STAFF REPORT
Director's Hearing
January 31, 2023

File: PLN17-10080

Appeal of the Open Space Easement Compatible Use Determination (CUD) for a New Single-Family Residence.

Owner: Martin & Rosario Gutierrez
Applicant: Hanna-Brunetti/D&Z Designs
Lot Size: 27.1 acres
APN: 728-24-008
Supervisorial District: 1

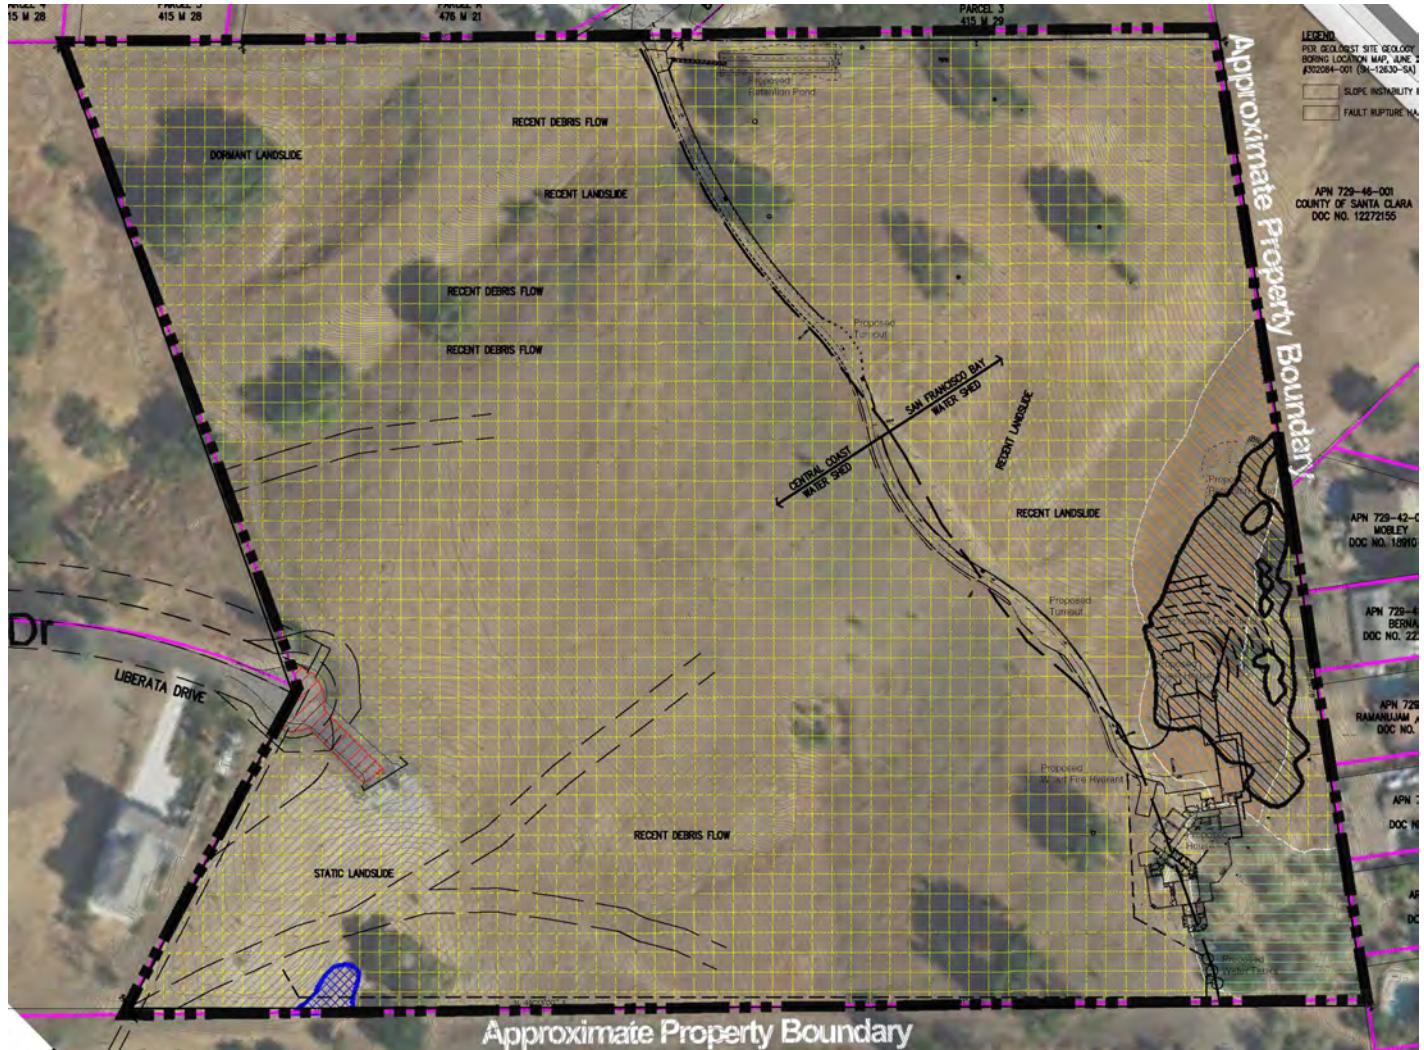
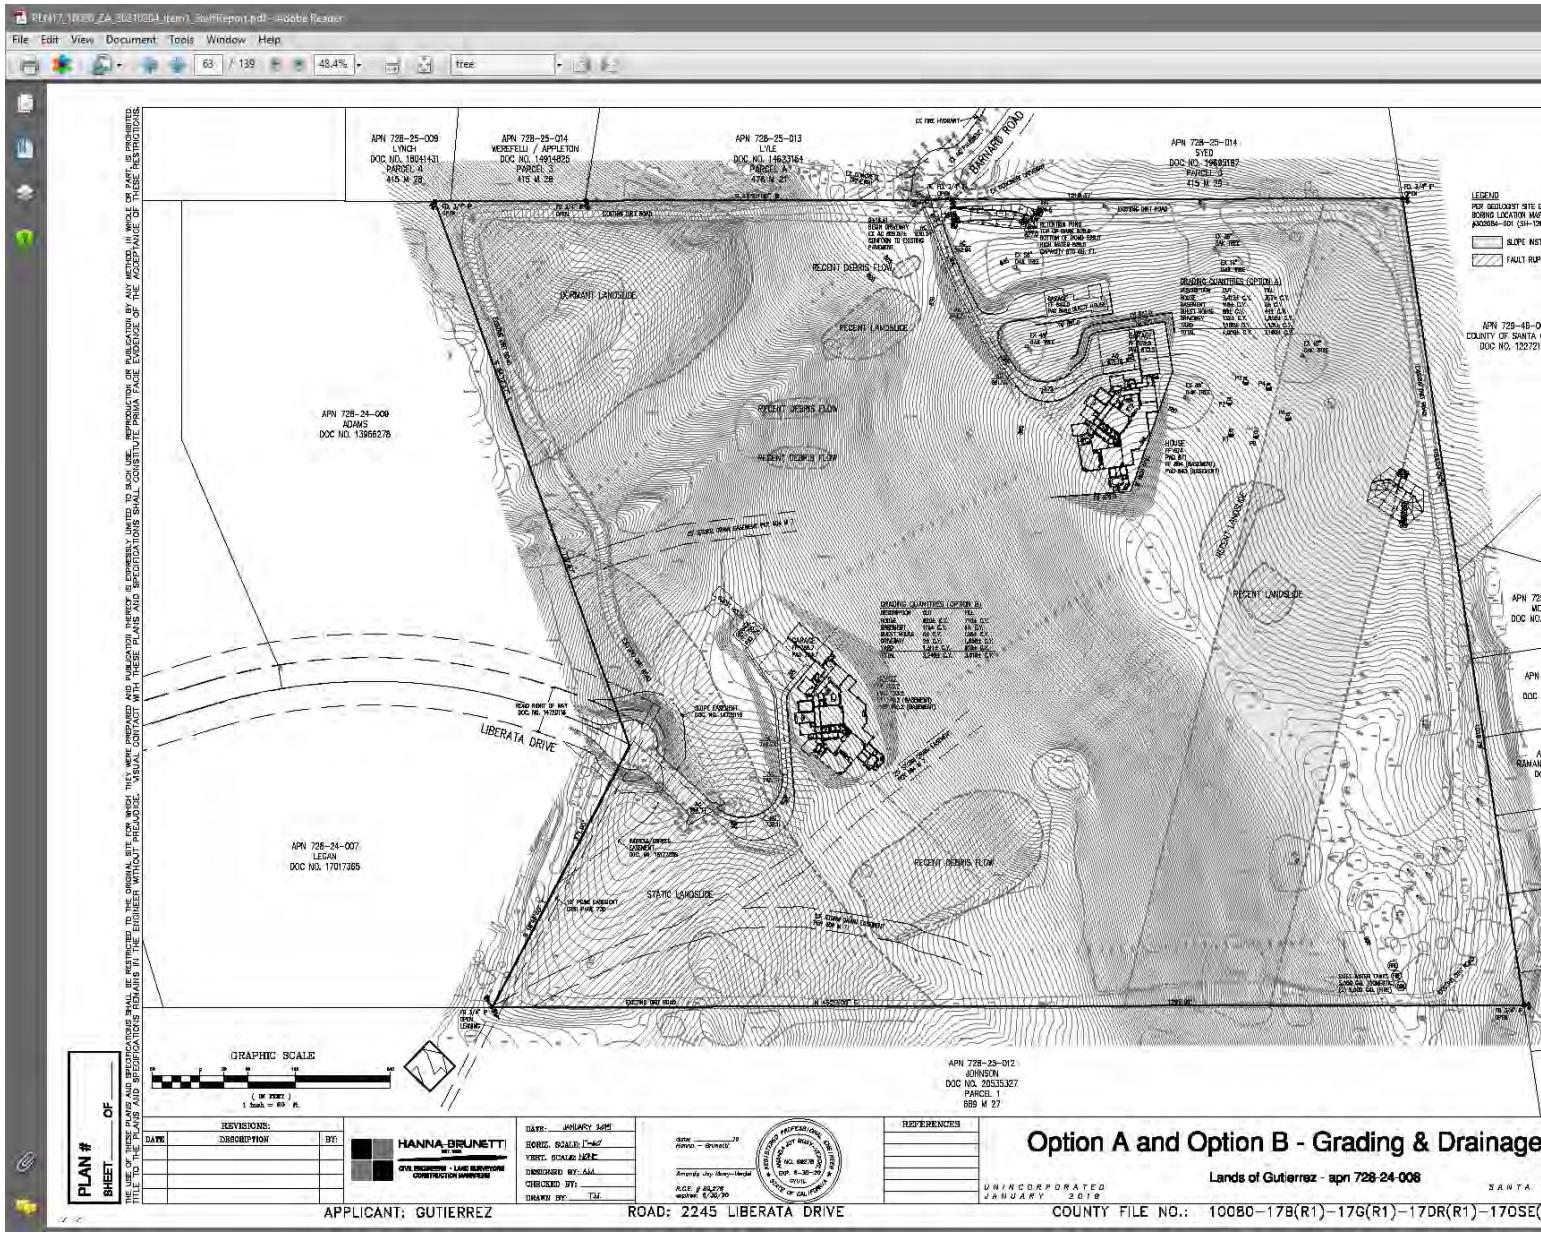
In the rare plant survey done by Live Oak Associates, Inc., it identified the Smooth Lessingia (a California Rare and Protected Rating (CRPR) 1B per the report from Live Oak Associates) as being present on the property. The included map in the Staff Package shows the area of the lot where this plant occurs:

By superimposing the map image on an aerial survey (I did this in photoshop by rotating, scaling, and aligning the lot outlines - it isn't perfect), it appears that the garage, proposed guest house, septic leachfield, and proposed retention pond all intersect with the area where the Smooth Lessingia was identified. (Note that the Legend for the different areas is visible in the full map above)

From this image, it appears that the proposed development will have a significant impact on a large portion of the area with Smooth Lessingia, as well as the impact on the previously mentioned 'Foothill Pine – Oak Woodland'.

lessingia but no other plants that are associated with serpentine soil. Smooth lessingia is a covered plant under the Santa Clara Valley Habitat Plan, and therefore, the mitigation and conditions of smooth lessingia is incorporated as part of the conditions of approval for the project under the Santa Clara Valley Habitat Plan. As the development is restricted by several geologic hazard and landslide areas throughout the property, mitigation measures have been incorporated in the conditions of approval to lessen impact to the smooth lessingia as much as possible.

SHEET
L-4

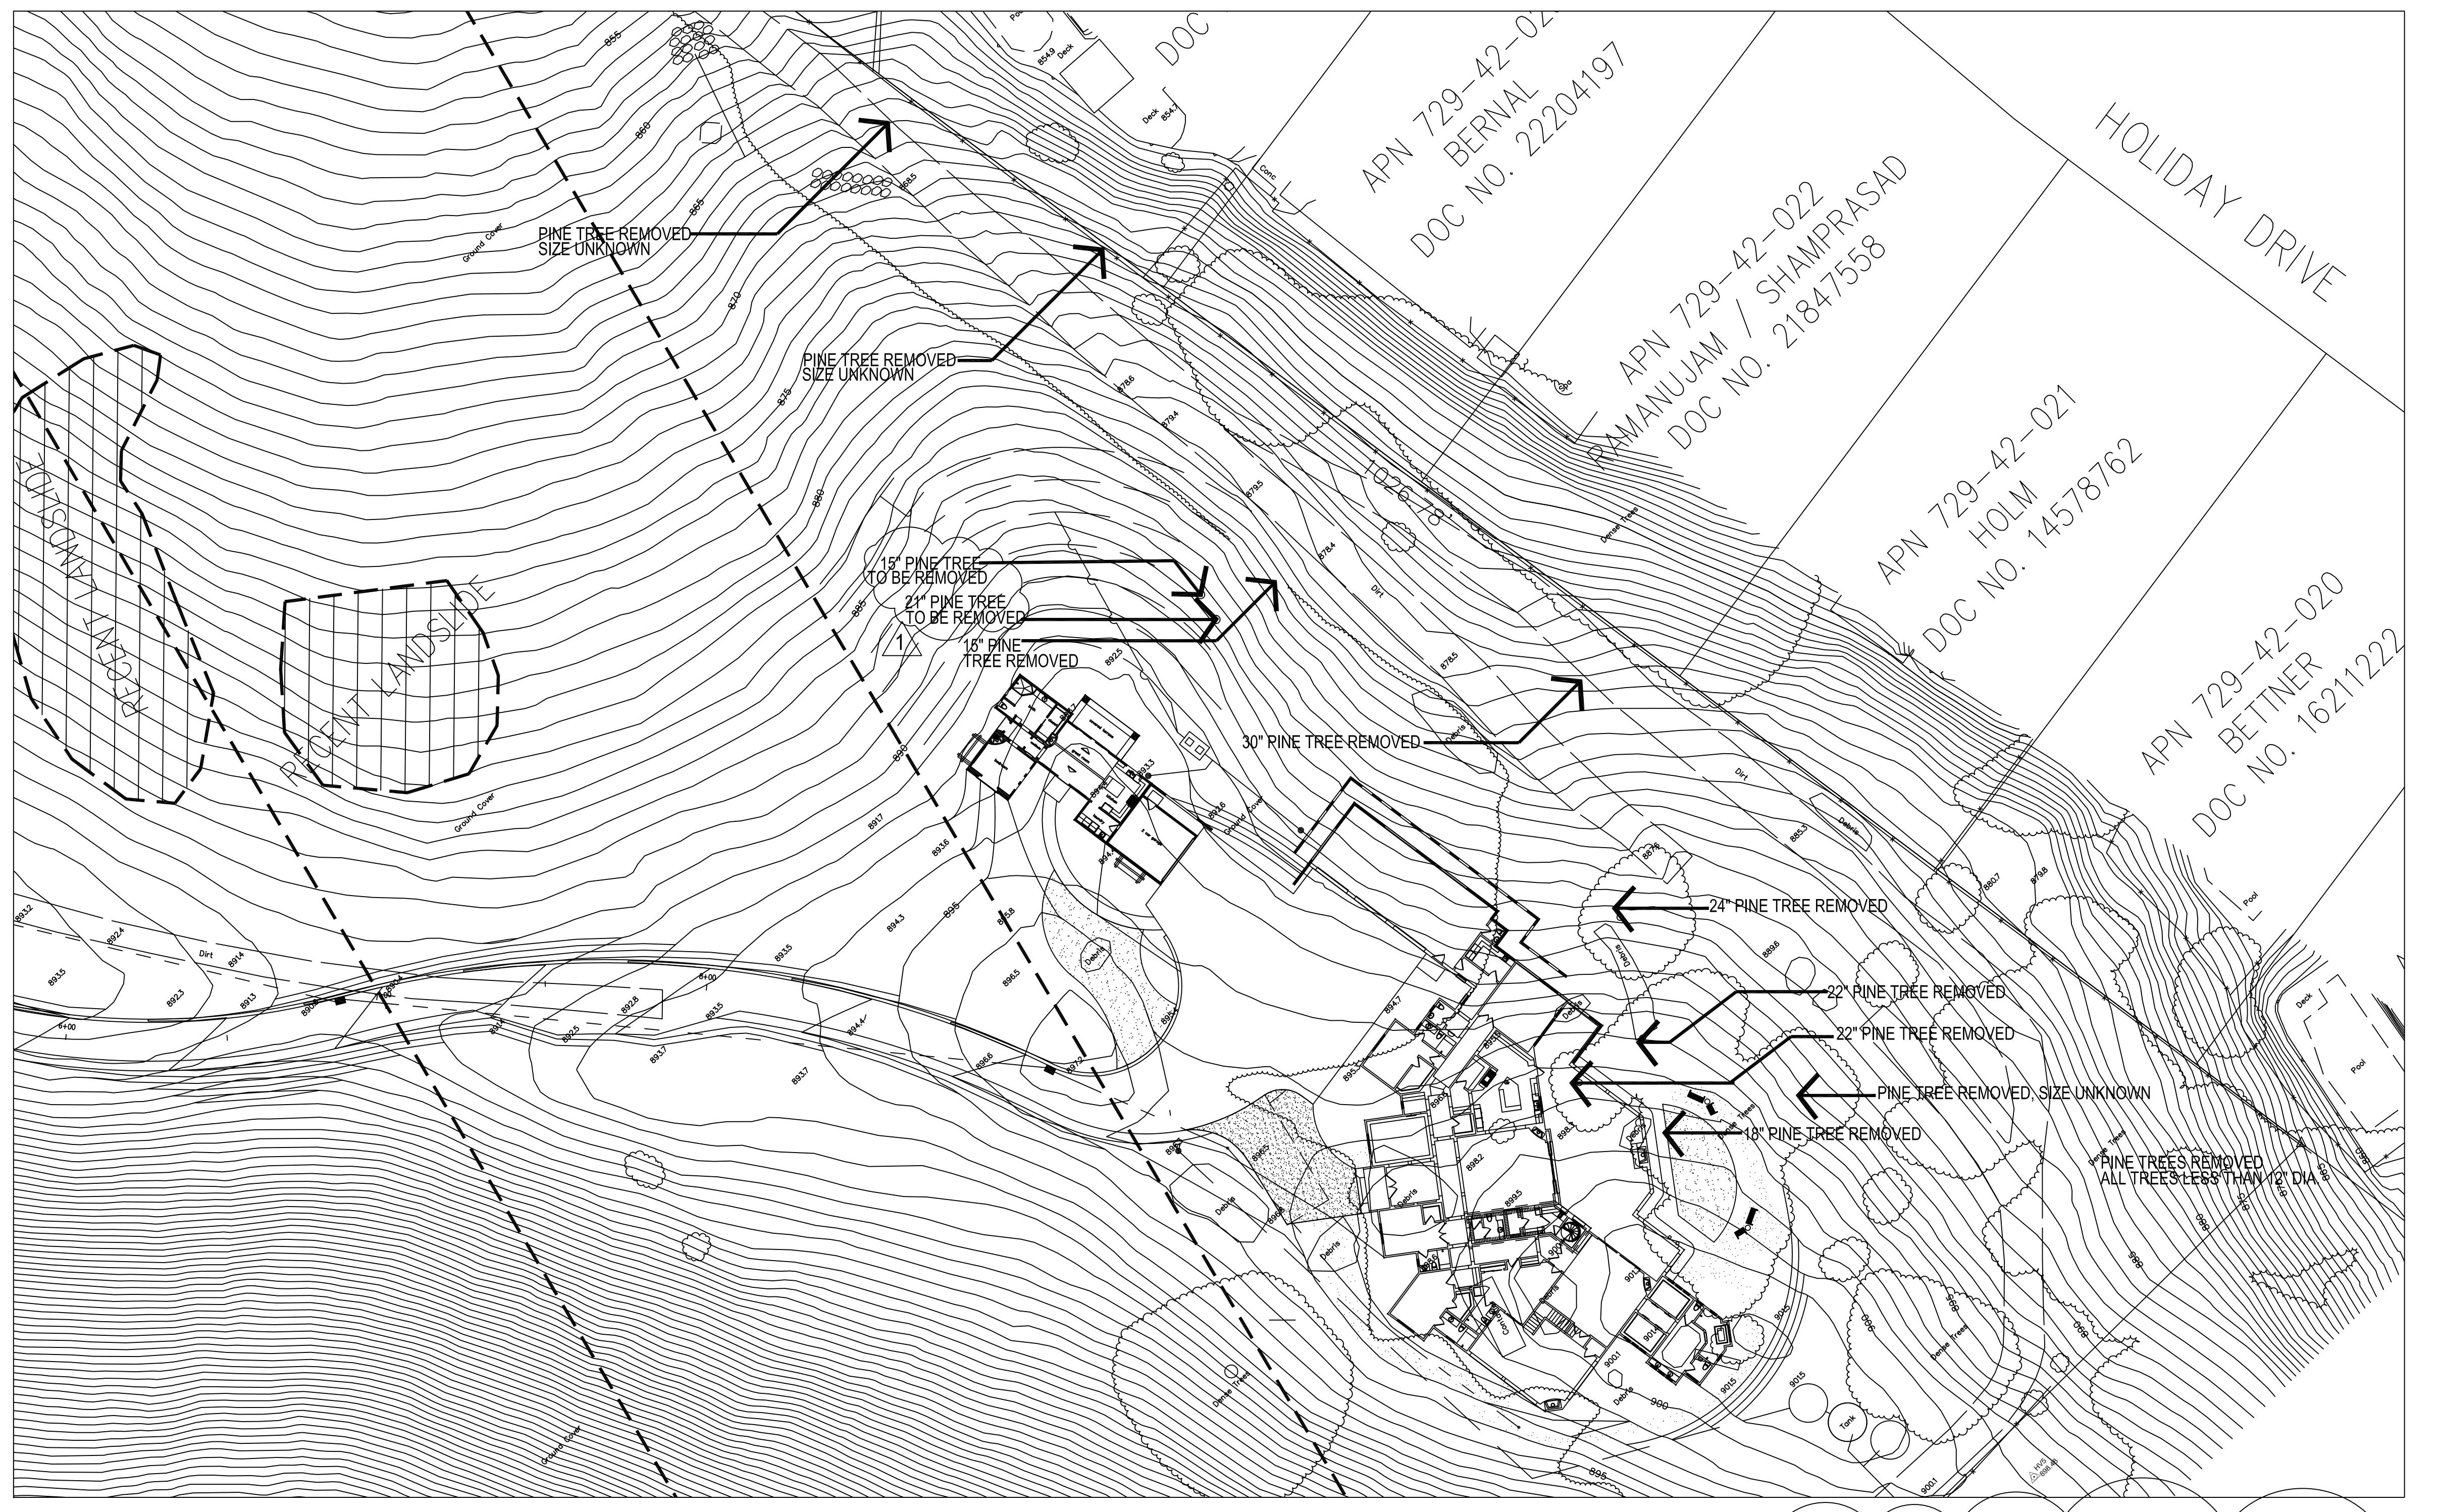
THIS SHEET SHOWS ALL TREES REMOVED, 9 TOTAL.
TREES TO BE REMOVED, 2 TOTAL.
REPLACEMENT TREES ARE SHOWN ON SHEETS L-1,
L-2, L-3 AND L-5. AT A RATIO OF 10:1 110 TREES
NEEDED, OVER 185 NEW TREES ARE BEING
PROPOSED.
